Modification of Development Consent

Development consent: **SSD 7308** granted by the Executive Director, Infrastructure Assessments on 7 May 2020.

Modification: **SSD 7308 MOD 1:** The modification includes the following amendments to the St Marys Intermodal development consent:

Appendix 1 is amended by deletion of the existing figure and insertion of the following figure:

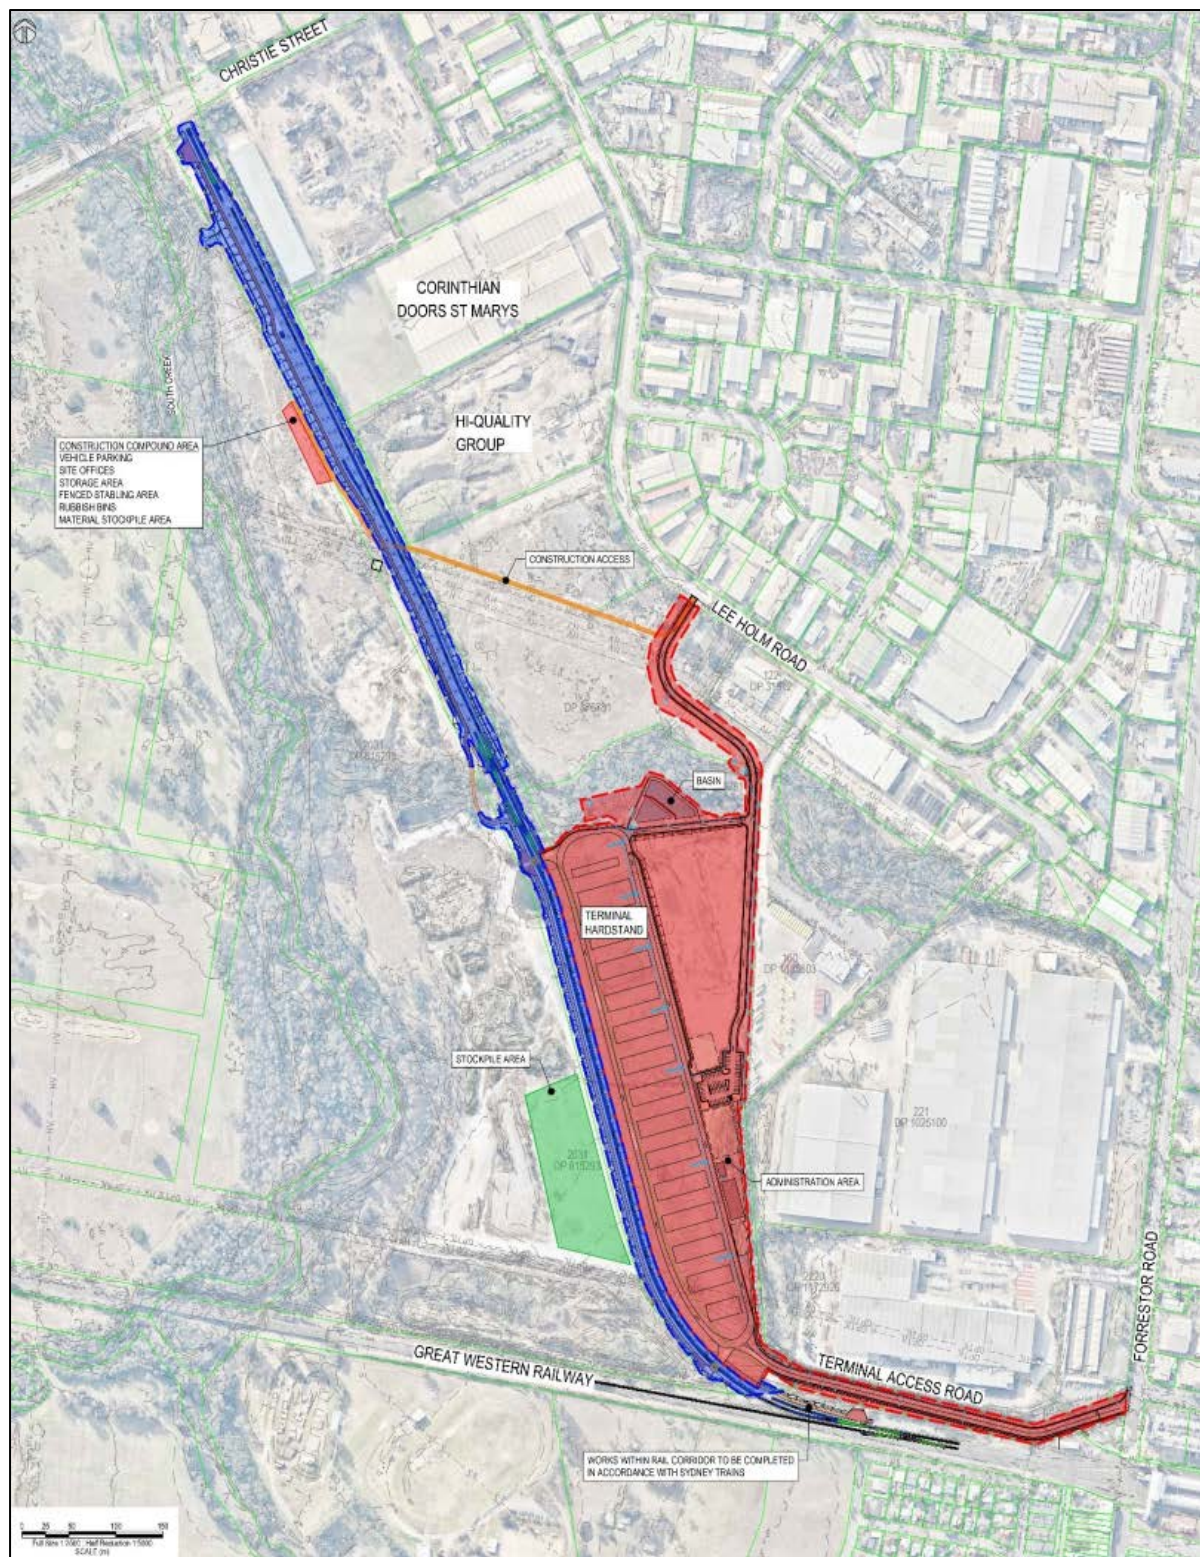
- re-lay the existing rail sidings (x2) within the existing rail corridor
- upgrade two existing level crossings and construct a 3.5 m wide one-way access track
- construct stormwater management facilities and discharge outlet
- establish a temporary construction compound to support rail refurbishment works
- revise the development layout boundary to include the rail refurbishment works area.
